SUBJECT: Invitation for Bid #11-2872DC  
North Water Reclamation Facility Expansion 1                      ADDENDUM #1

**NWRF Expansion Phase I  
County Project No. 6011283  
ADDENDUM 1  
November 3, 2011**

**CHANGES TO THE DRAWINGS**

## NWRF Golf Course Lake 2009 Lake Elevations

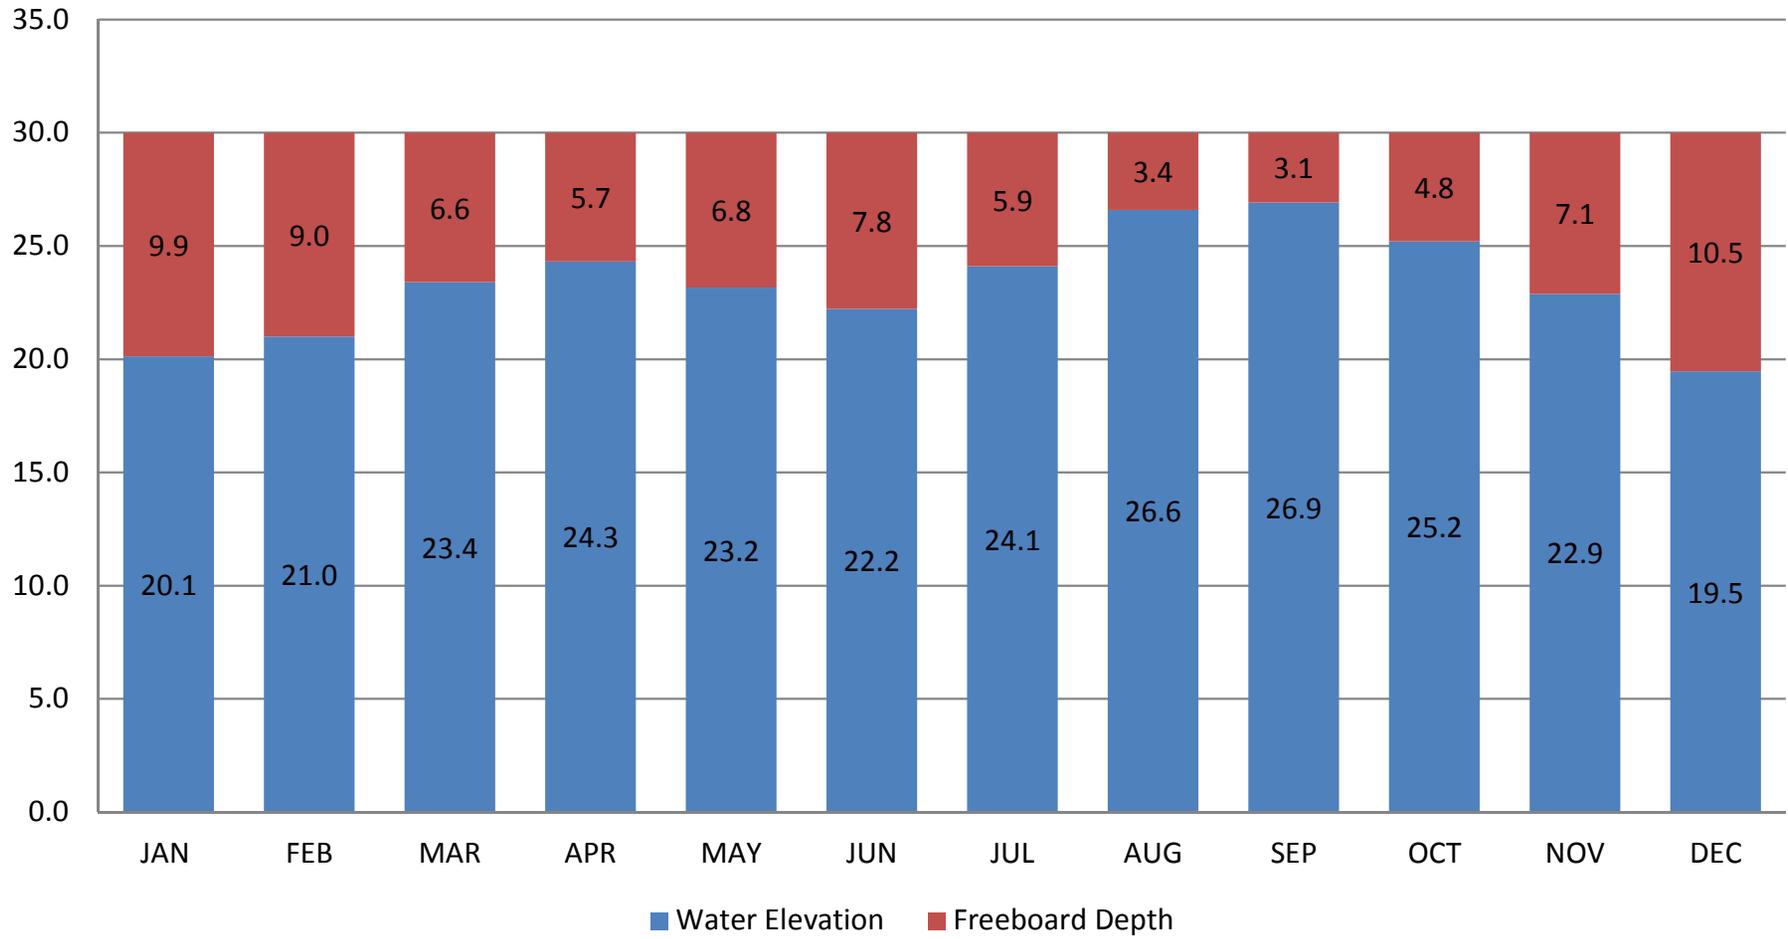
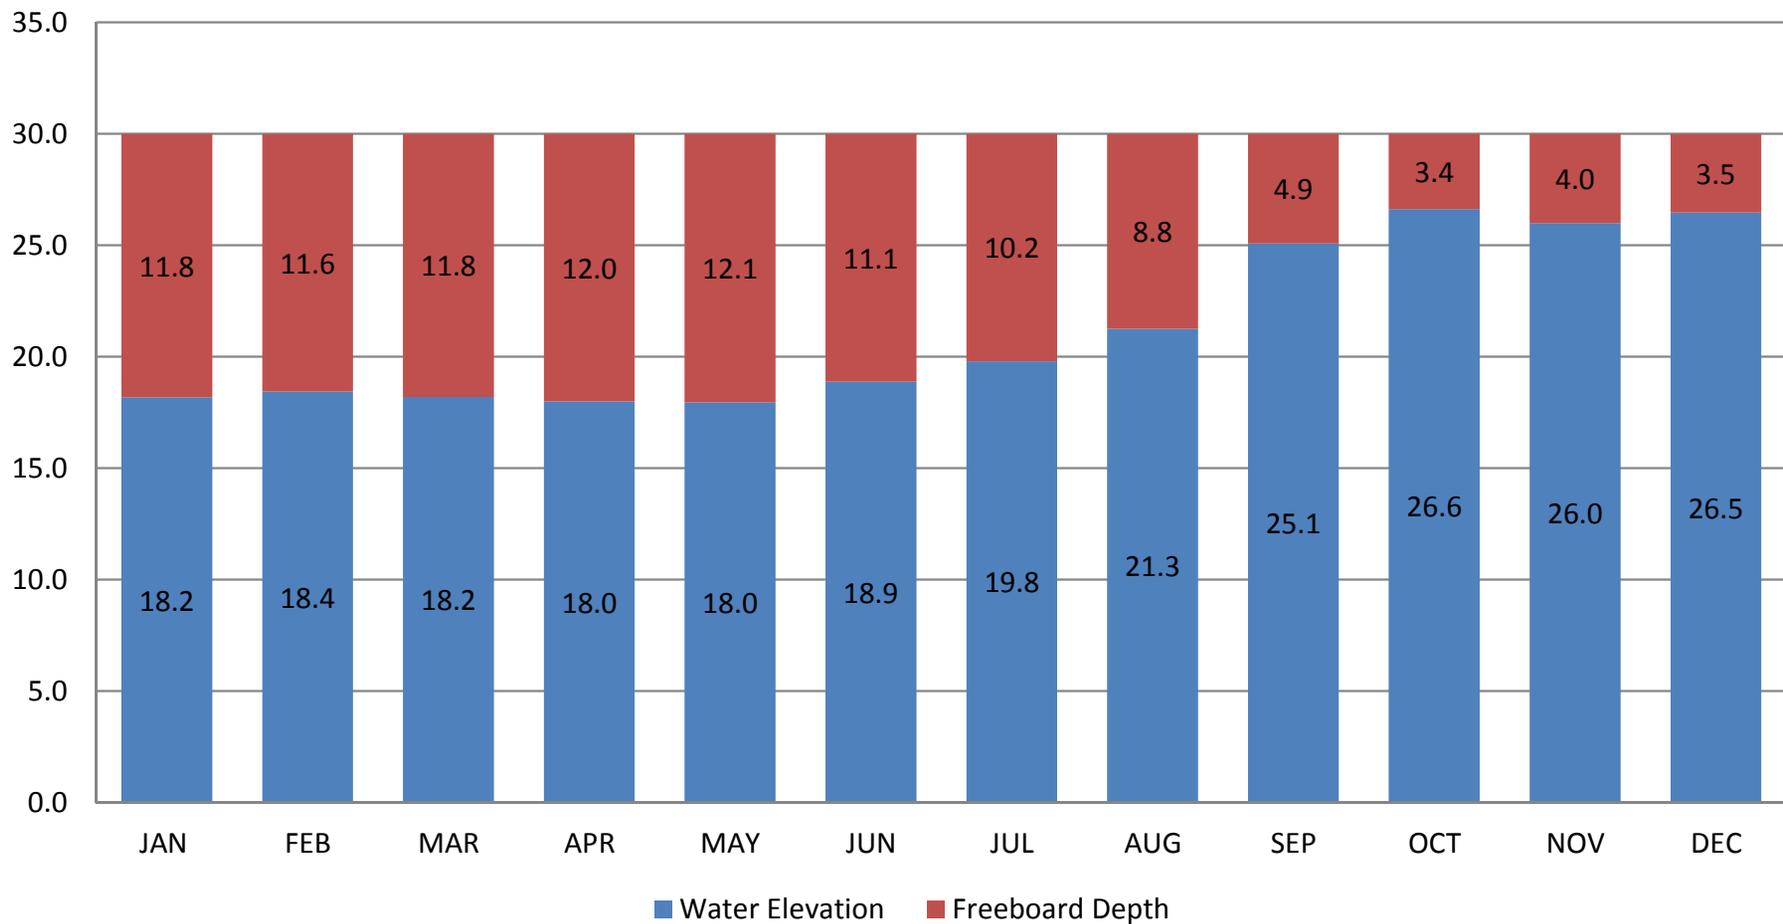
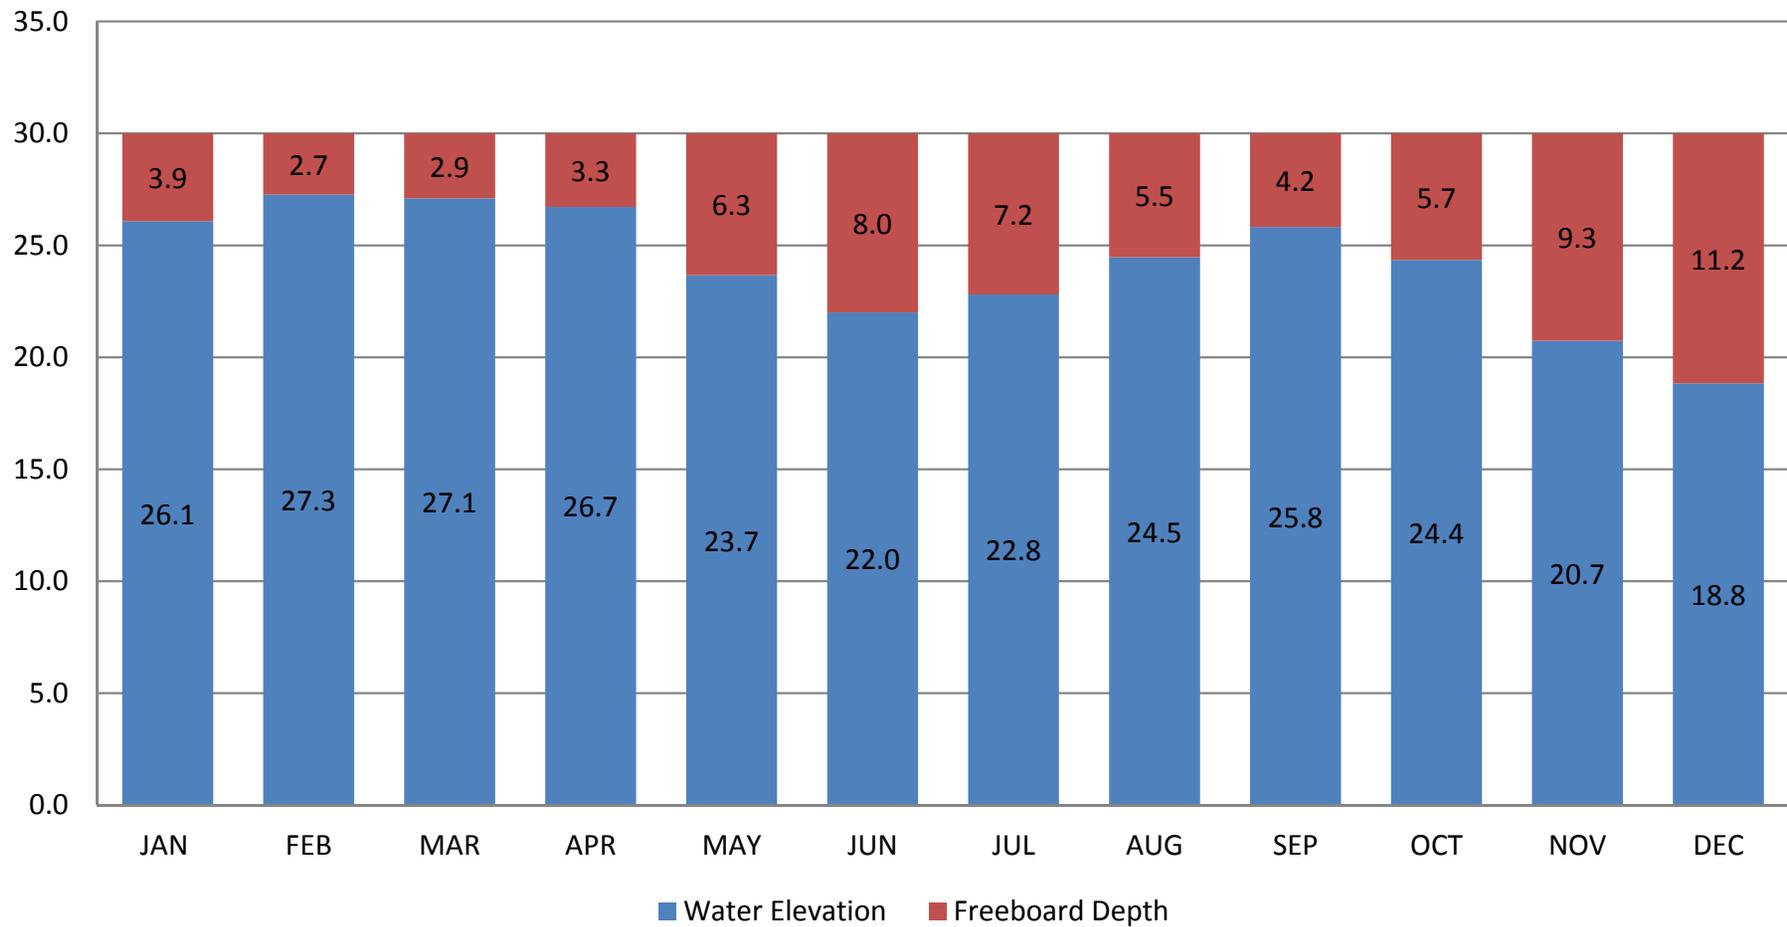
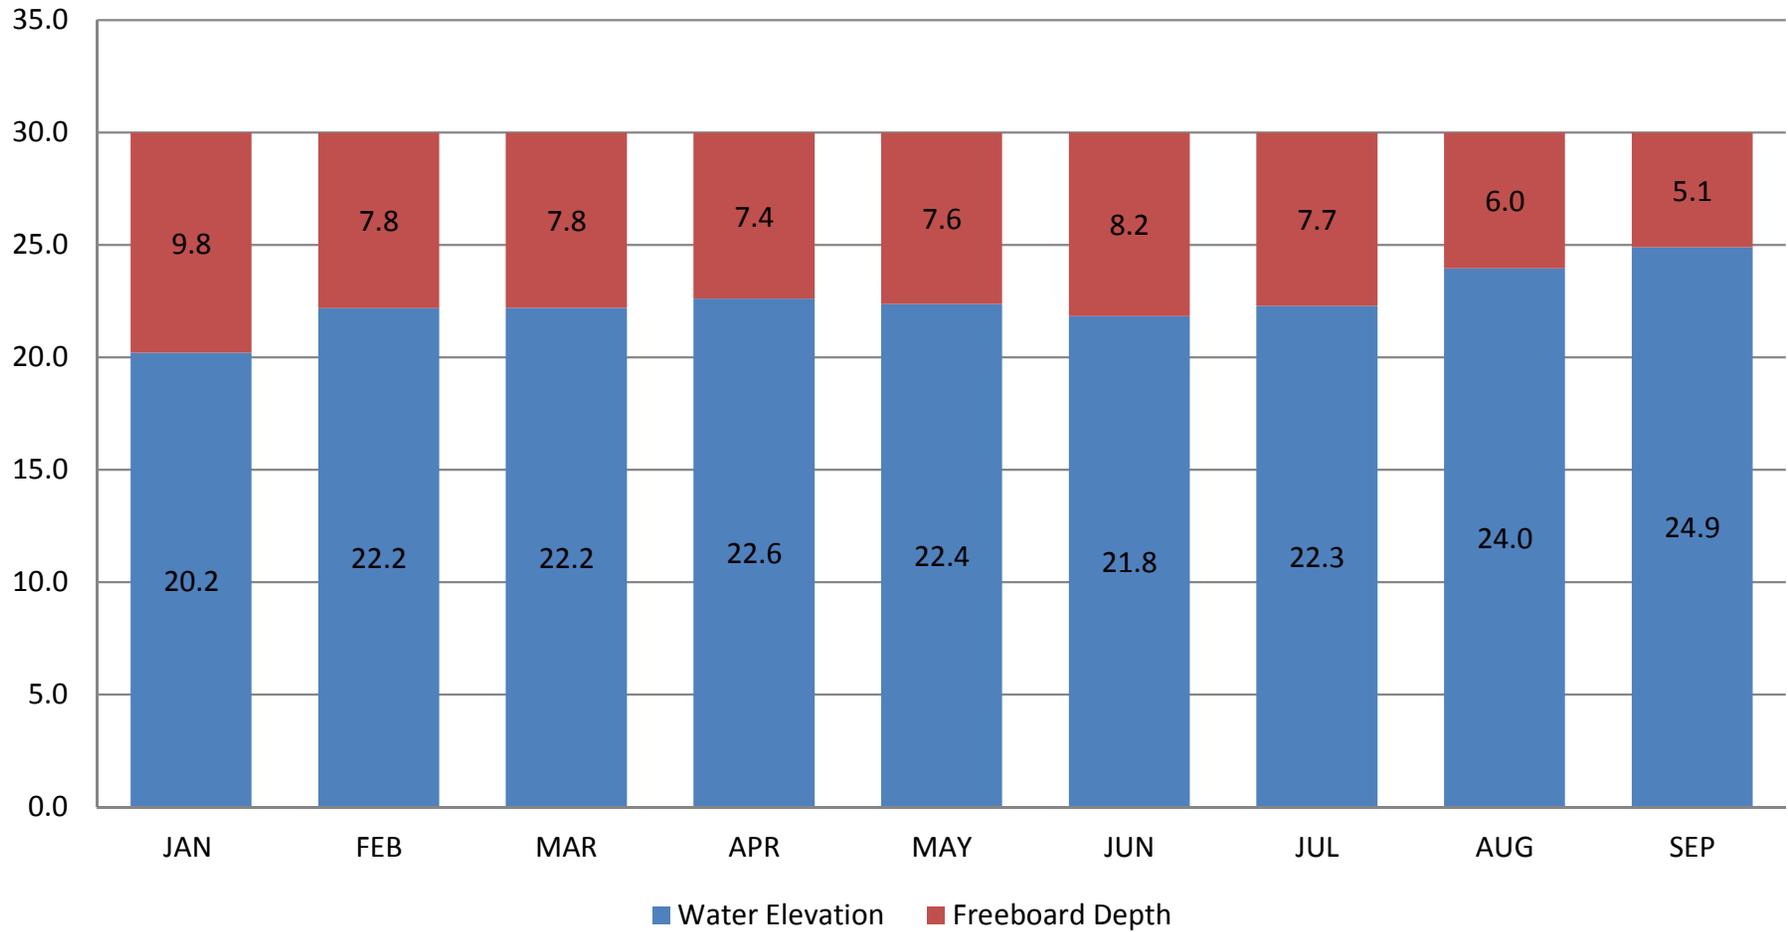
25. Can water level elevations in each lake be provided for a minimum of a year? **Historical Water Levels available for the East Lake and the Golf Course Lake are show in graphical form and attached to this Addendum. It should be noted that this is no guarantee of future conditions.**
